## Groundwater Application Review Summary Form

Application # G- 19216

# PUBLIC INTEREST REVIEW FOR GROUNDWATER APPLICATIONS

**A. GENERAL INFORMATION:** Applicant's Name: Chemeketa Community College County: Marion

Figure 1. Well Location Map

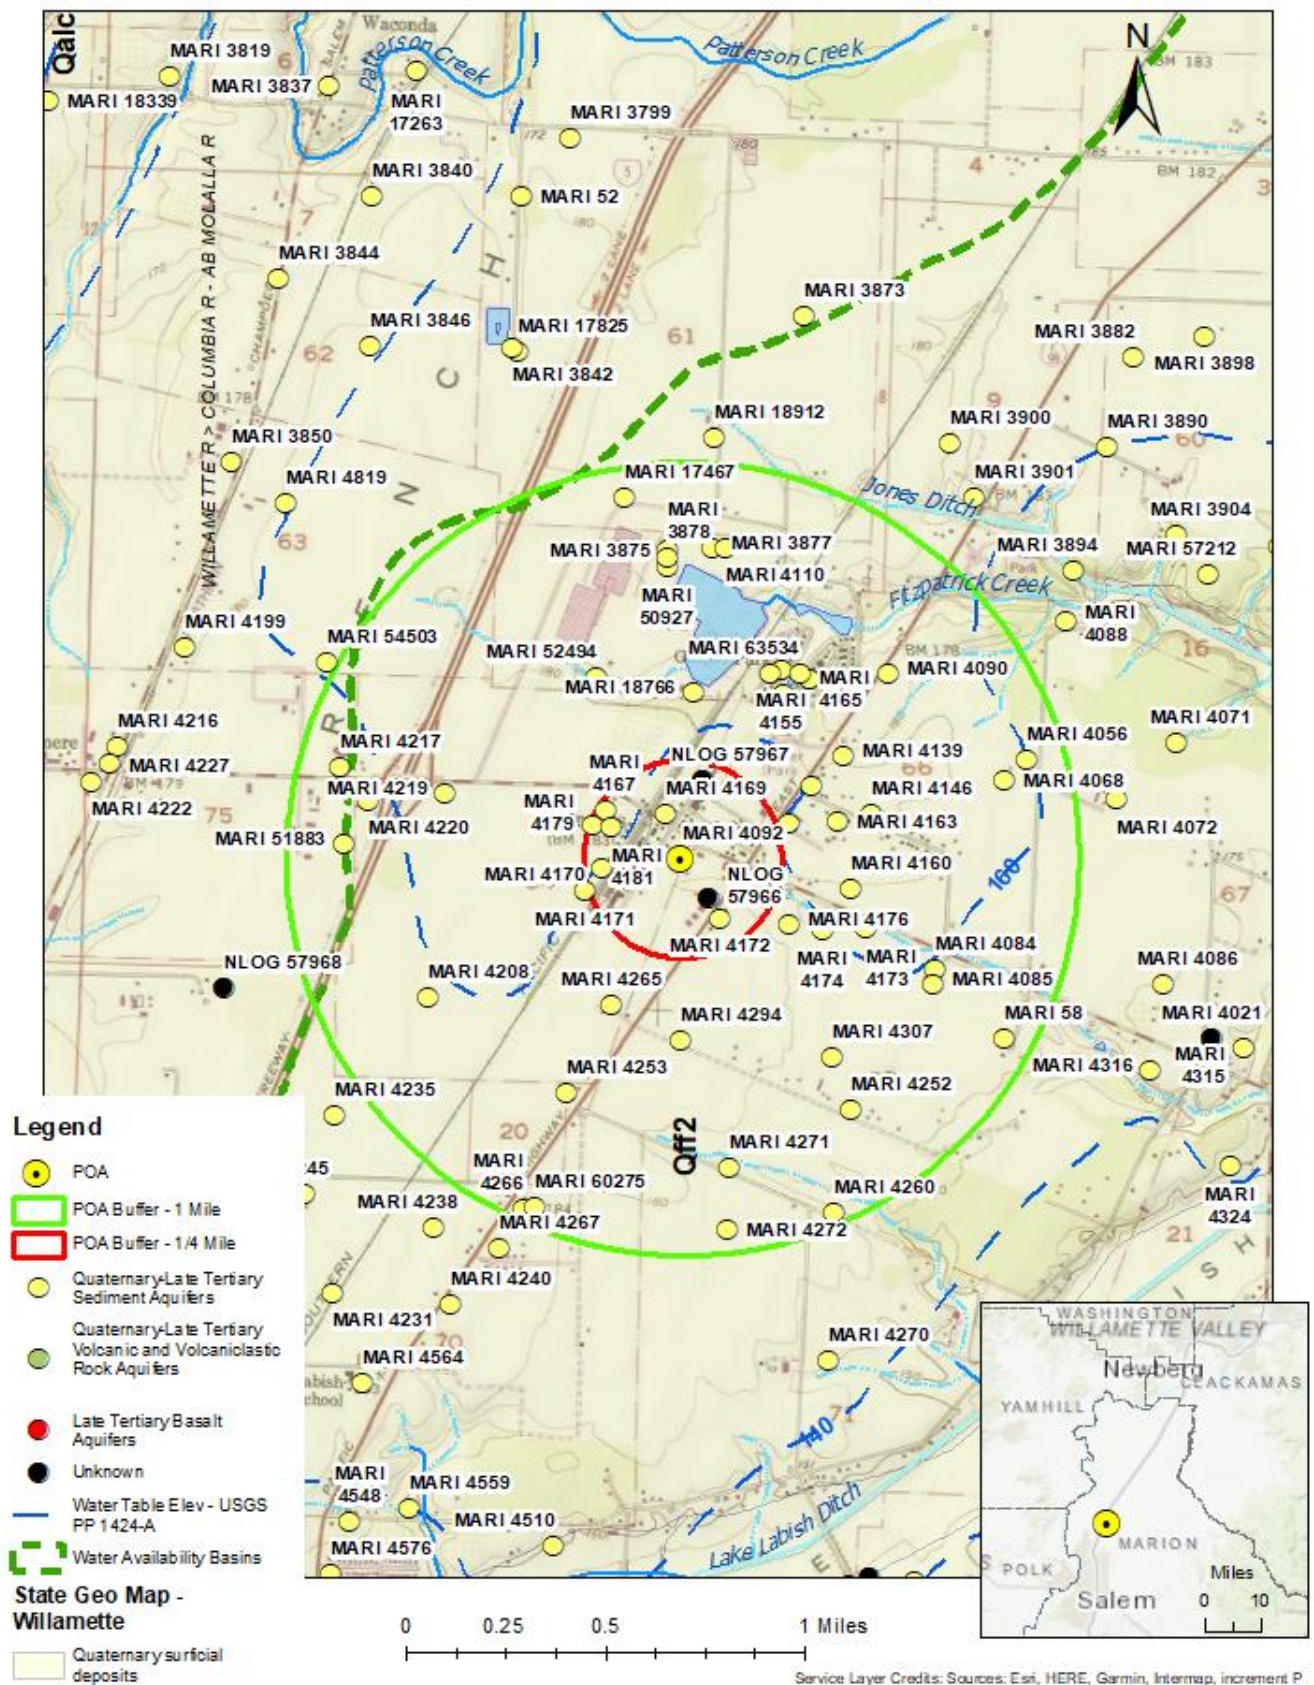
- B3. **Groundwater availability remarks:** The proposed POA well (MARI 4092) is located in the Central Willamette Valley (Figure 1) and is completed at the depth of 315 ft bls. The well will produce groundwater from the depth of 229 – 300 ft bls. The groundwater producing zone is a part of the Willamette Aquifer, which is primarily composed of unconsolidated sand and gravels (Gannett and Caldwell, 1998). The Willamette Aquifer in the area is estimated to be 80-120 ft thick and is overlain by 60-80 ft of low permeability silt and fine sand, known as the Willamette Silt Unit. The aquifer is underlain by the Willamette Confining Unit, which is comprised of fine-grained distal alluvial fan and low gradient stream deposits locally separated by thin layers of clay, silt, and sand. The majority of the wells in the immediate vicinity draw groundwater from the Willamette Aquifer from the depth of around 100ft (Figure 2a). Deeper wells (> 200 ft bls) in this area have generally reported higher yields. The applicant's requested rate 300 gpm (~0.8 cfs) is less than the median yield (695 gpm) reported for wells deeper than 200 ft bls (Figure 2b).

The nearest permitted well (NLOG 57966) to the propose POA is located about 630 ft southeast (Figure 1). Interference with NLOG 57966 was quantitatively estimated using a Theis (1935) time-drawdown model for a confined aquifer. Hydraulic parameters used for the analysis were derived from regional data and studies (Pumping Test Reports; Conlon et al., 2005; McFarland and Morgan, 1996). The analysis shows that drawdown would not exceed 15 ft at a distance of 630 ft (at NLOG 57966) after 365 days of pumping at the maximum requested rate in scenario 2 when median aquifer transmissivity value is used from the pumping test reports in the area (Figure 4). Therefore, the proposed use unlikely to cause well-to-well interference with NLOG 57966 or similarly located wells which would meet the definition of injury.

Figure 2a. Well Statistics

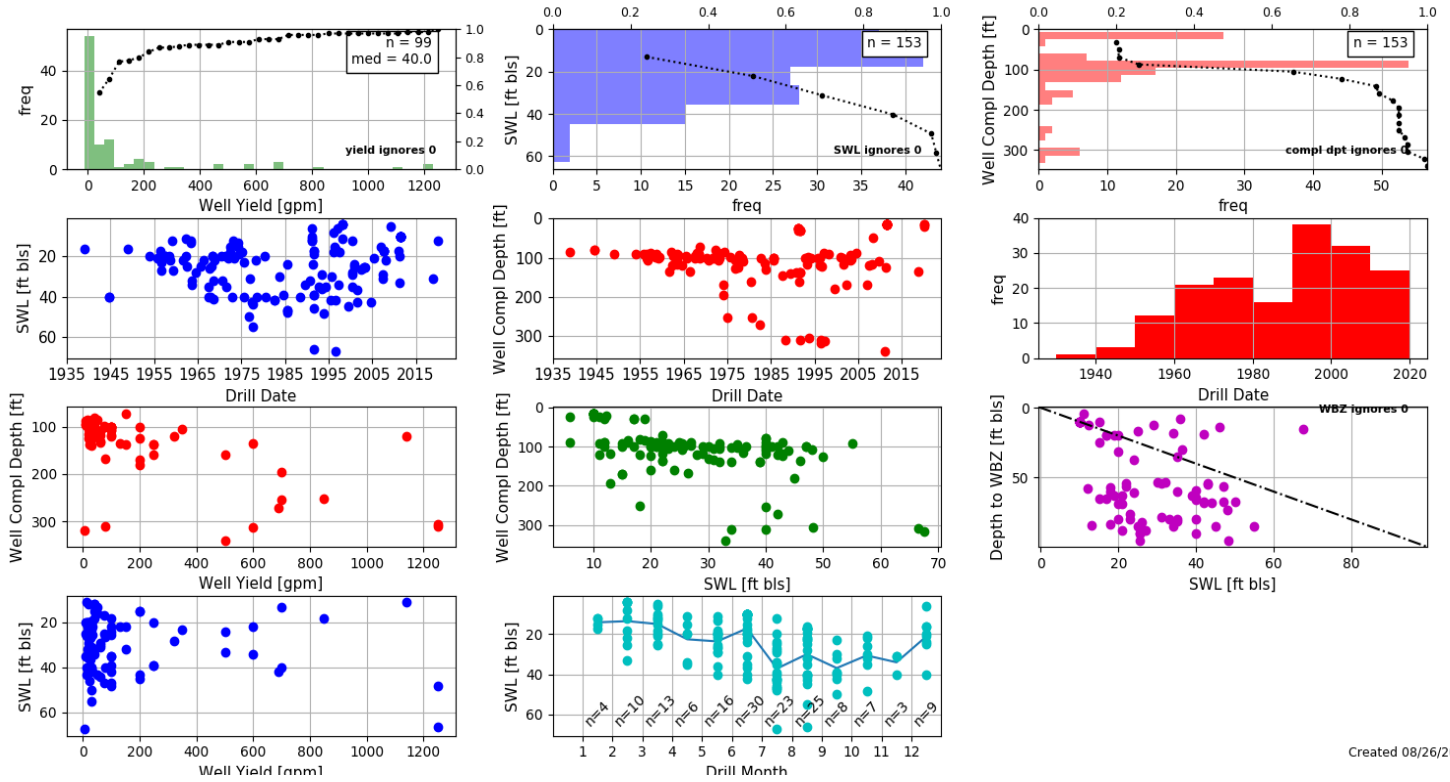
**Basis for aquifer confinement evaluation:** Reported water levels in nearby wells are predominantly above the applicable water-bearing zones (Figure 2). Additionally, available well logs in the area indicate a ~60-80 ft thick low permeability clay/silt layer overlying sand and gravel aquifer (Figure 5).

Figure 3a. Water-Level Measurements in Nearby Wells (1961-2022)

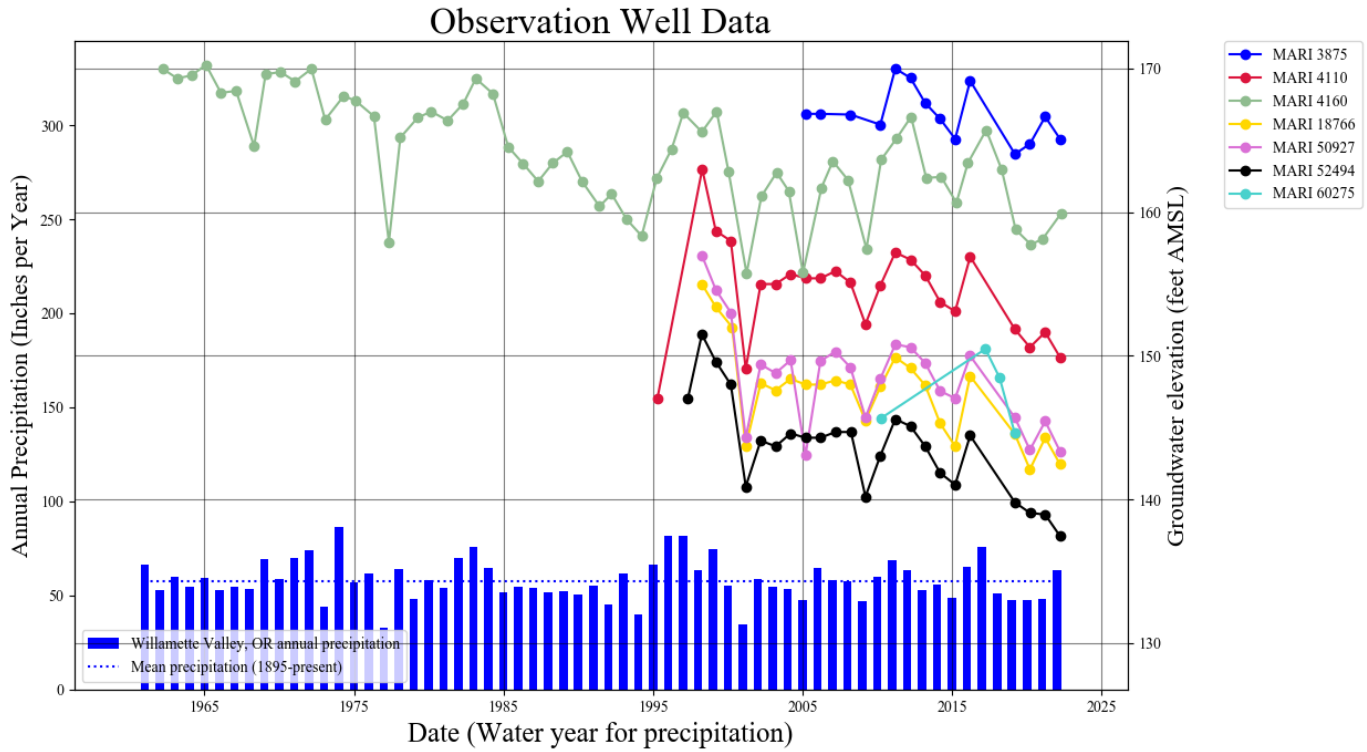
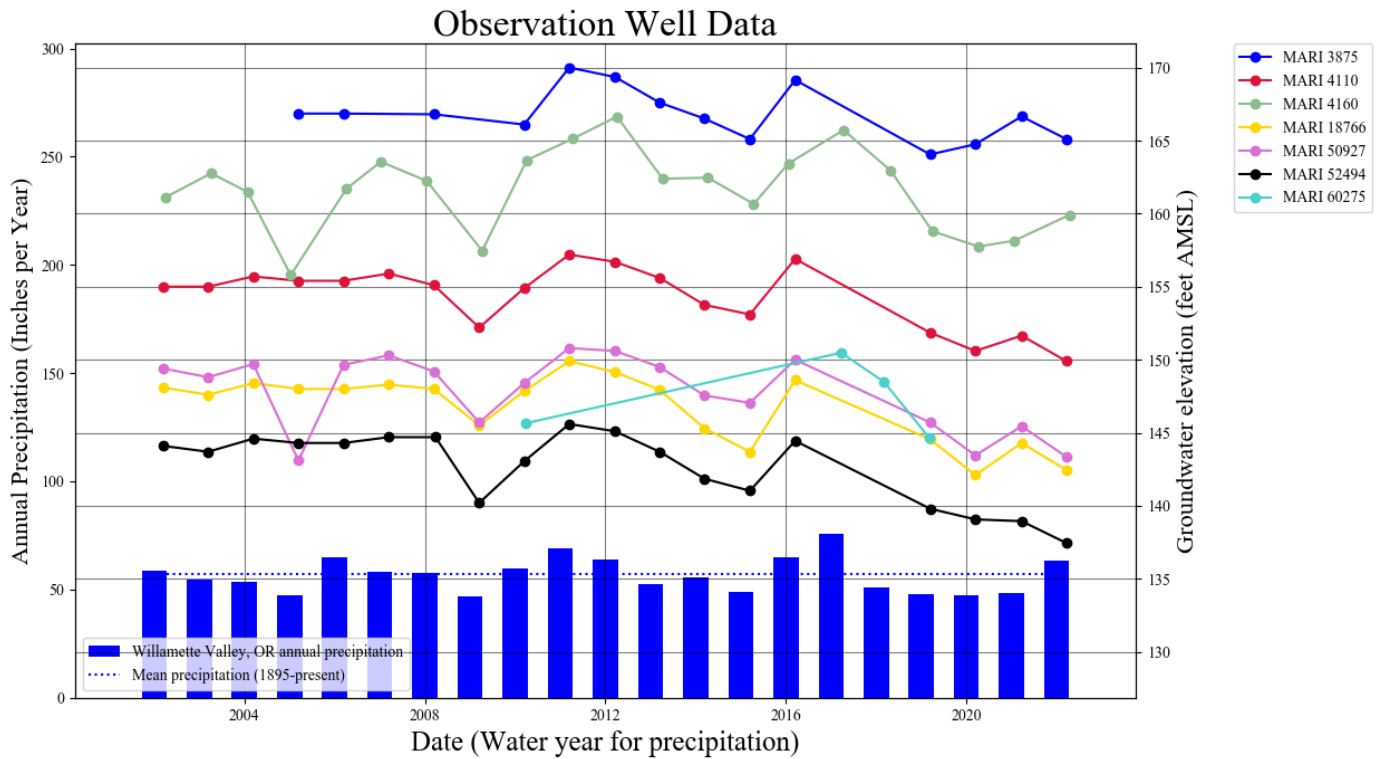
Static water levels (SWL) are typically 20-50 ft bls in this area of the Willamette aquifer. Nearby wells show some decline in groundwater level over the past 10 years, though much of this can likely be attributed to drier-than-average climatic conditions in recent years (Figure 3). Groundwater has declined by up to 8 ft in the area within the last 10 years.

**Figure 6. Stream Depletion Model Parameters and Output**

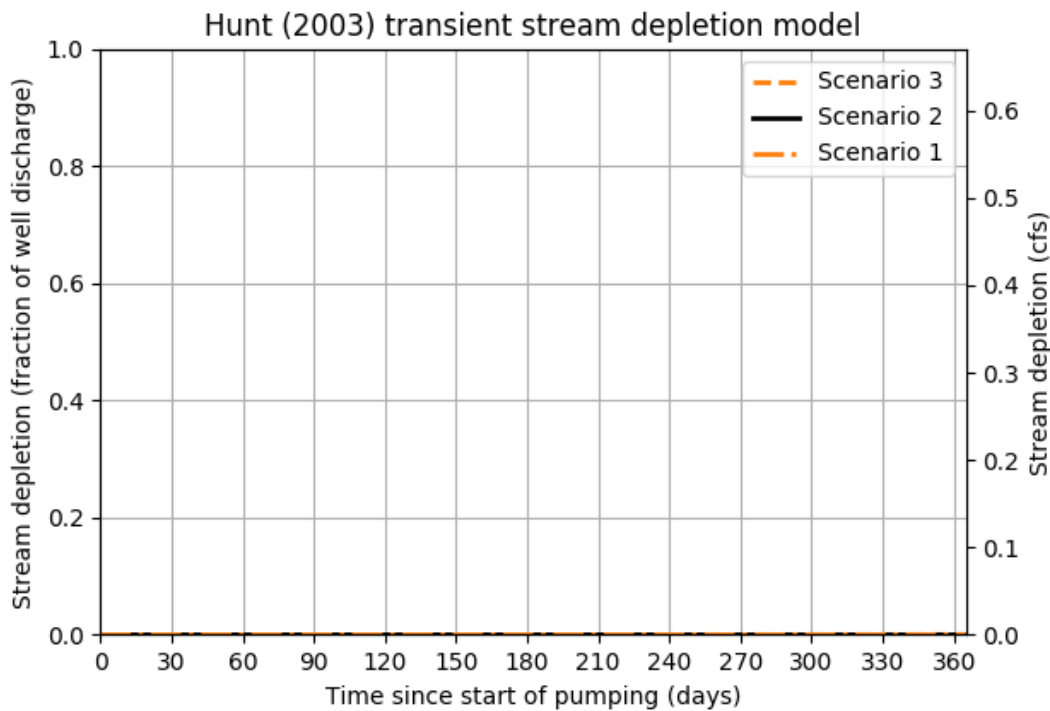
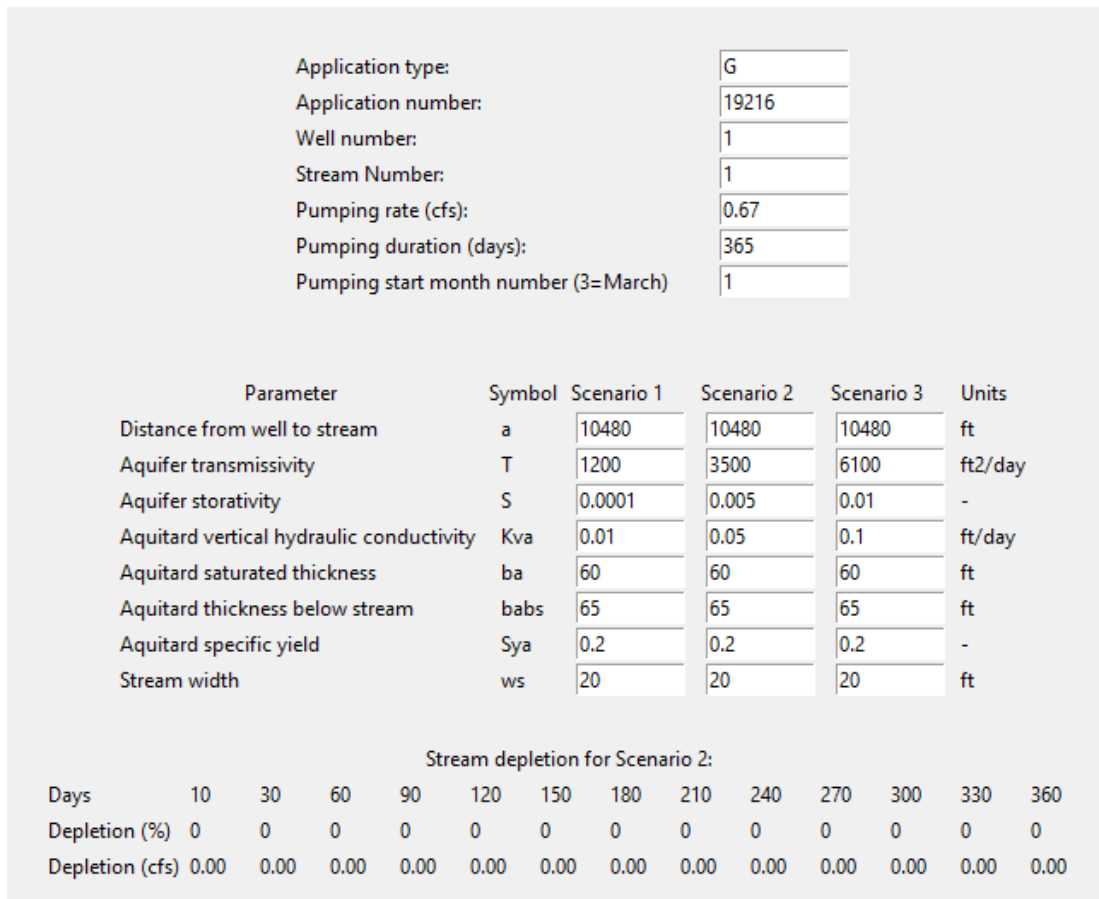
**Basis for impact evaluation:** Given the large distance between the proposed well and Patterson Creek combined with existing knowledge of the hydrogeologic regime in this area, it is unlikely for the well to cause substantial interference. The anticipated interference with SW1 due to the proposed use was quantitatively estimated using the Hunt (2003) model. Hydraulic parameters used for the analysis were derived from regional data and studies (Pumping Test Reports; Conlon et al., 2005; McFarland and Morgan, 1996) or are within a typical range of values for the given parameter within the hydrogeologic regime (Freeze and Cherry, 1979). Results indicate that interference with SW1 is minimal and is not anticipated to exceed 25 percent of the rate of withdrawal within the first 30 days of continuous pumping.
